COMMUNITY DEVELOPMENT DEPARTMENT REPORT

SUBJECT: H-2024-0043
Newkirk East MDA, PP

A Preliminary Plat and Development Agreement Modification to convert 216 apartments into 95 single-family attached homes on 10.08 acres of land zoned Traditional Neighborhood Residential (TN-R).

E. Landscape Plan (date: 7/3/2024)

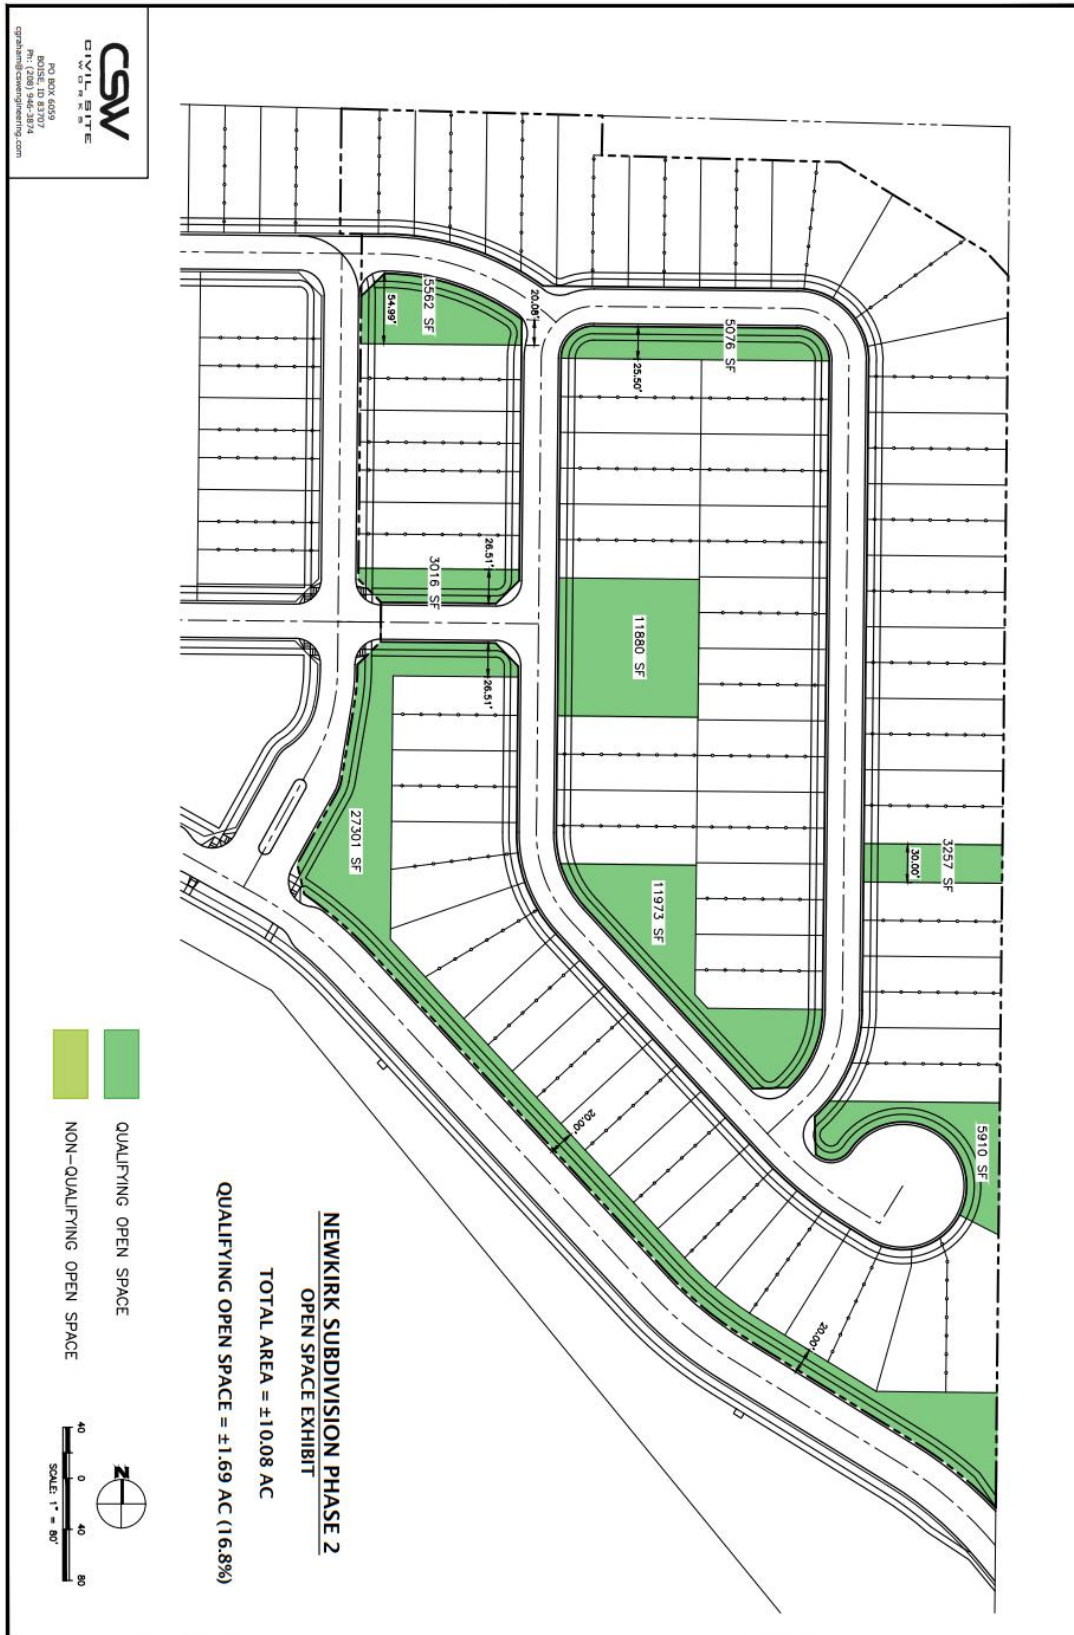
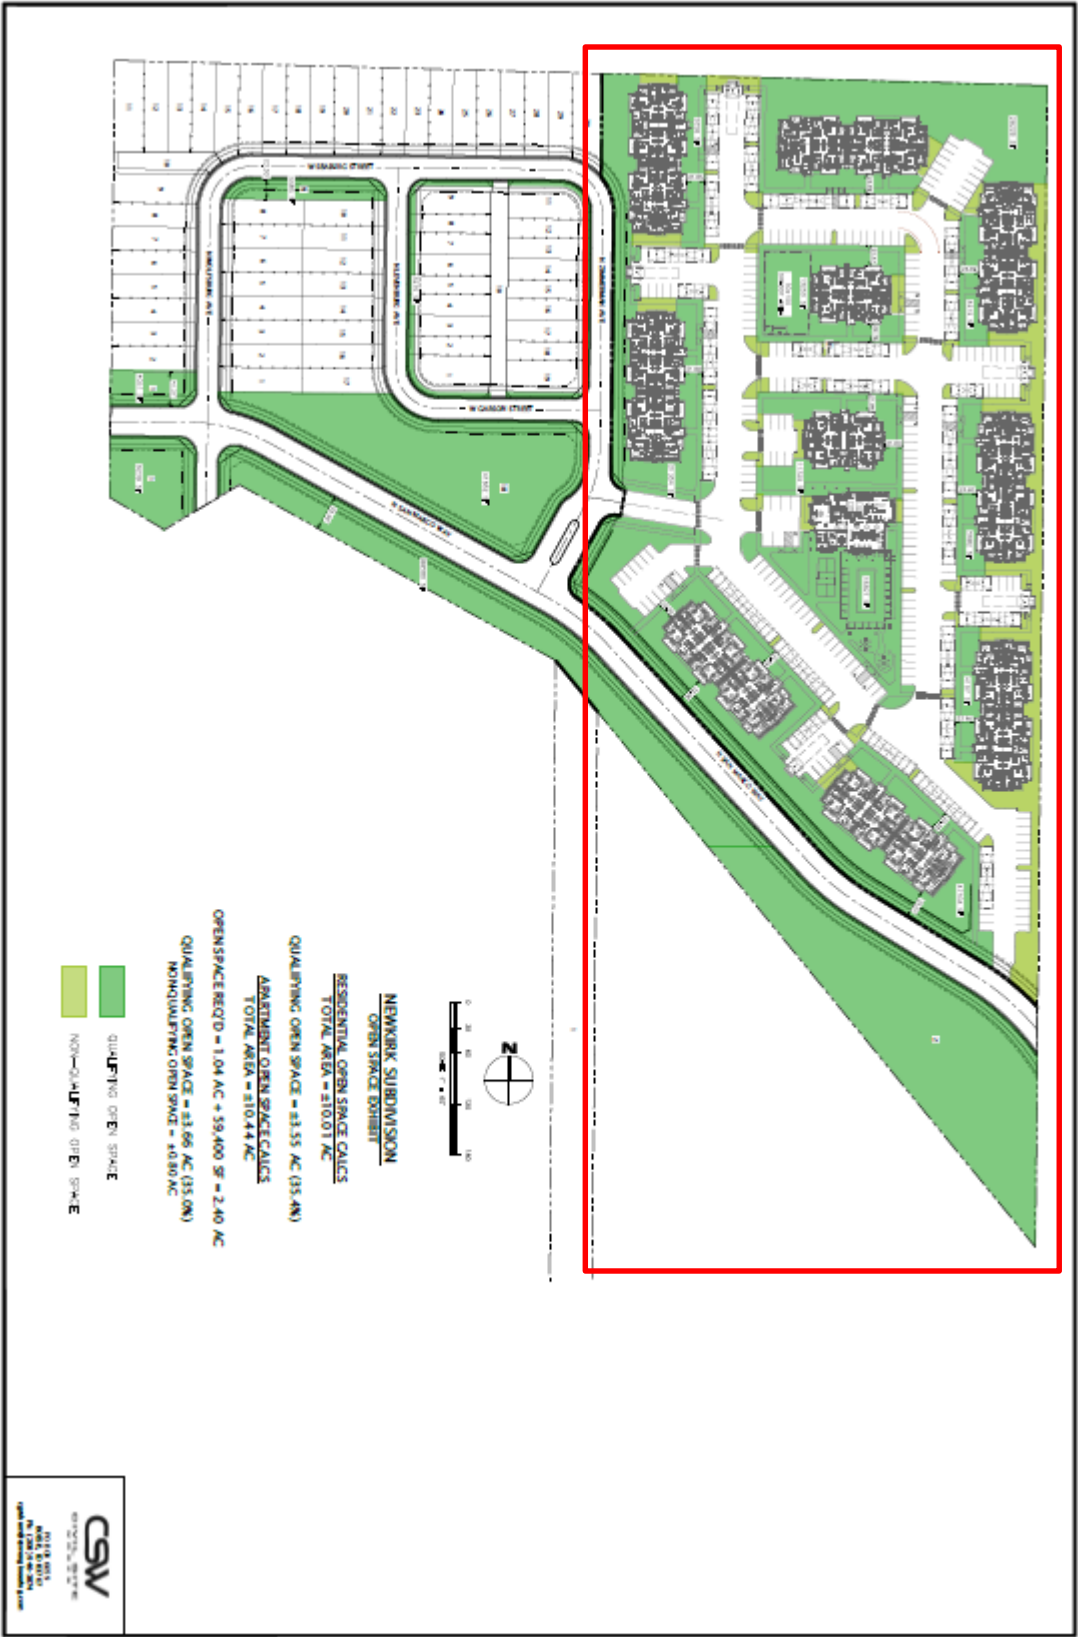
An 8-foot-wide parkway with Class II trees is required along all local streets per UDC Table 11-2D-6, landscaped per the standards listed in UDC 11-3B-7C.

Per the UDC the minimum width of parkways planted with Class II trees shall be eight (8) feet. The width can be measured from the back of curb where there is no likely expansion of the street section within the right-of-way; the parkway width shall exclude the width of the sidewalk. Class II trees are the preferred parkway trees. The applicant will be required to revise their landscape plan to show Class II trees.

- g. Depict an 8-foot wide parkway with Class II trees along all local streets per UDC [Table 11-2D-6](#), landscaped per the standards listed in UDC [11-3B-7C](#). Include the linear feet of parkways with the number of required vs. provided trees in the Landscape Calculations table that demonstrates compliance with UDC standards.

H. Parking Exhibit

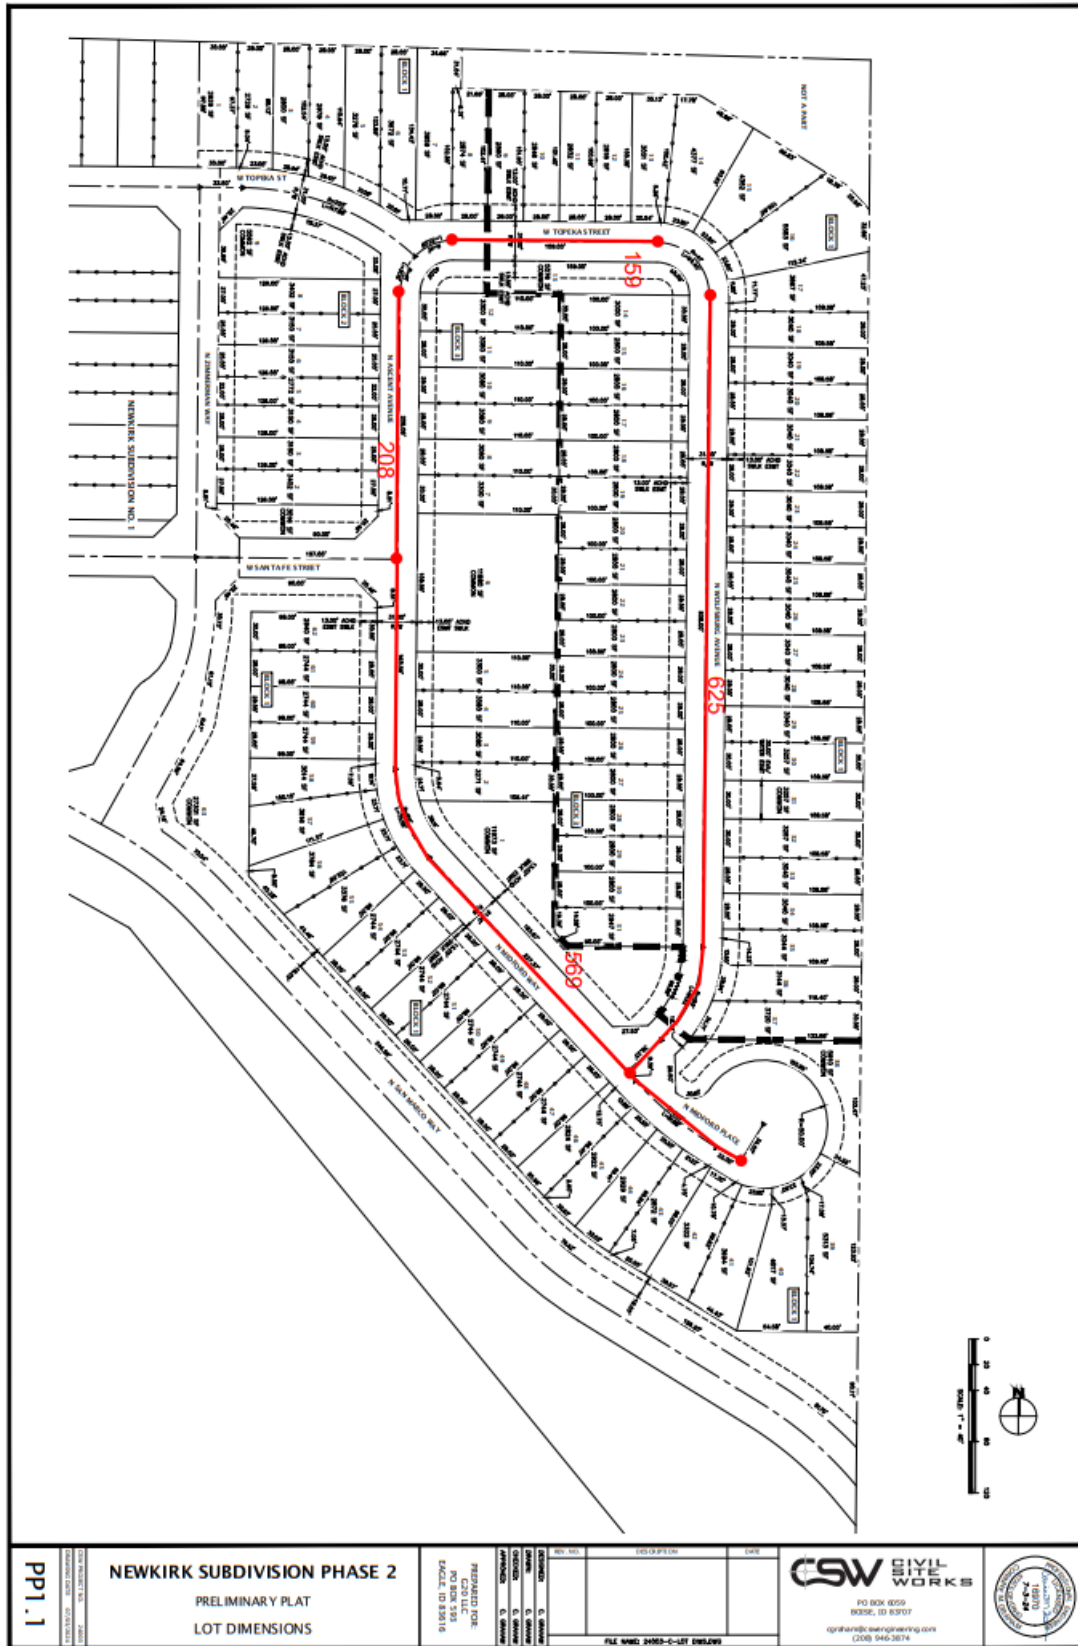
All single-family attached and townhouse dwelling units are proposed to have a 2-car garage with a 2-space parking pad consistent with UDC Table 11-3C-6 for 1- to 4-bedroom units; if any units contain more than 4 bedrooms, an additional two (2) spaces are required with at least one (1) of those being an enclosed space. Per the applicant, an additional 48 on-street parking spaces (0.5+ per home) are available for residents and guests as shown on the parking exhibit in Section VII.H.

I. Block Length Exhibit (date: 7/3/2024)

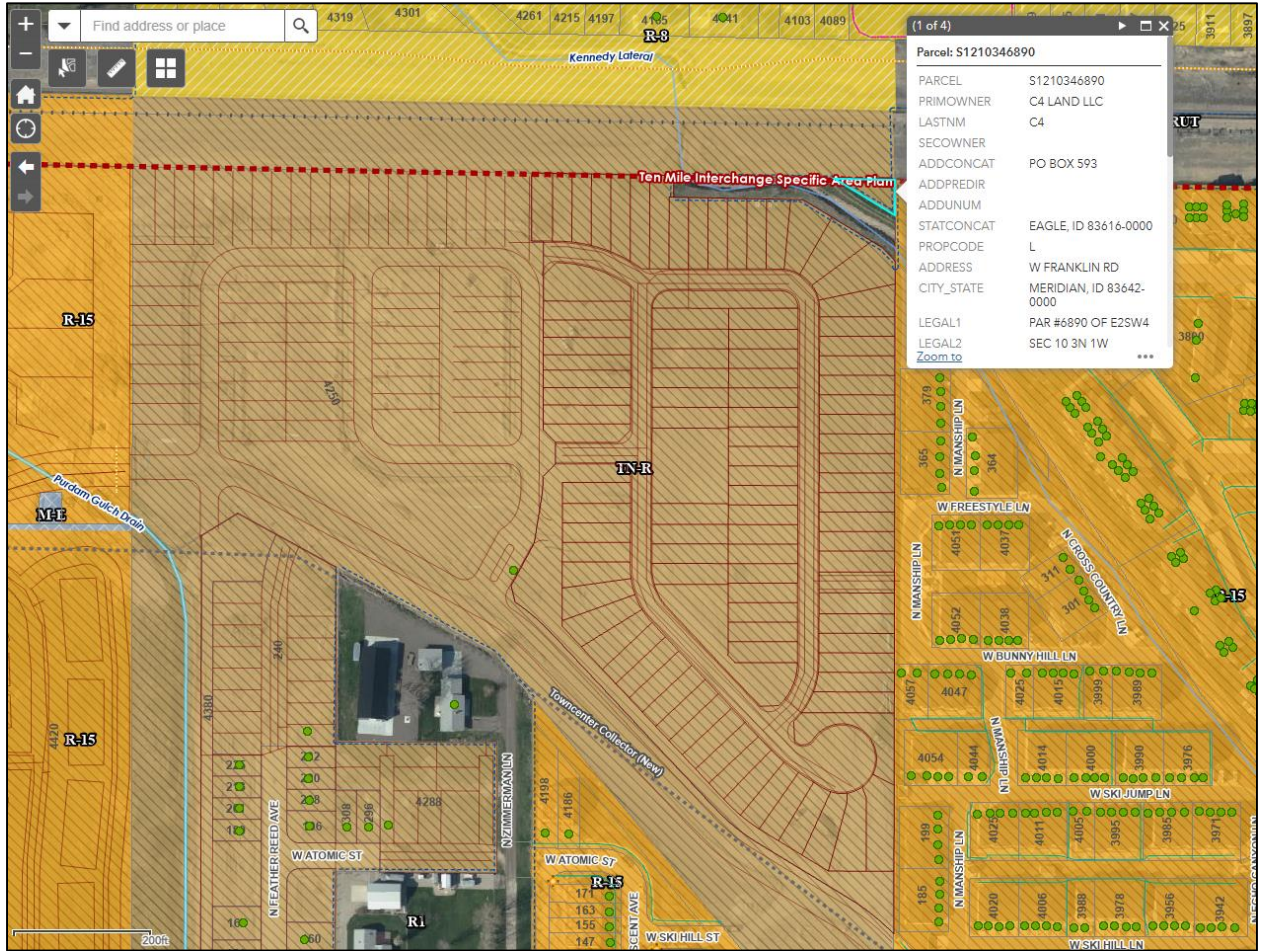
UDC 11-6C-3- regulates block lengths for residential subdivisions. Staff has reviewed the submitted plat for conformance with these regulations. In the TN-C and TN-R districts, no block face shall be more than five hundred (500) feet in length without an intersecting street or alley, except as allowed in subsection (F)(3). Subsection (F)(3) states where a pedestrian connection is provided, the maximum block face may be extended up to seven hundred fifty (750) feet in length in the TN-R District.

The applicant has several blocks lengths that exceed the 500 feet which need to be shorten or justification needs to be provided as to why they cannot meet the requirement. The applicant has provided an emergency access to N. Manship Lane within the Entrata Farms Subdivision No. 2, which counts towards a break in the block length on the east side of the roadway. The applicant can provide access to the open space area along N. Ascent Avenue from N. Wolfsburg Avenue to break up the block length on the west side of the road. Revise the plat map to bring the block length along A. Wolfsburg Avenue into compliance by adding a pedestrian facility along Block 3, in the vicinity of lots 20-23 to connect to the common lot on Lot 3, Block 3.

- **Revise the plat map to bring the block length along A. Wolfsburg Avenue into compliance by adding a pedestrian facility along Block 3, in the vicinity of lots 20-23 to connect to the common lot on Lot 3, Block 3.**

4. Add a pedestrian facility along Block 3, in the vicinity of lots 20-23 to connect to the common lot on Lot 3, Block 3.
 5. The final plat shall include the following revisions:
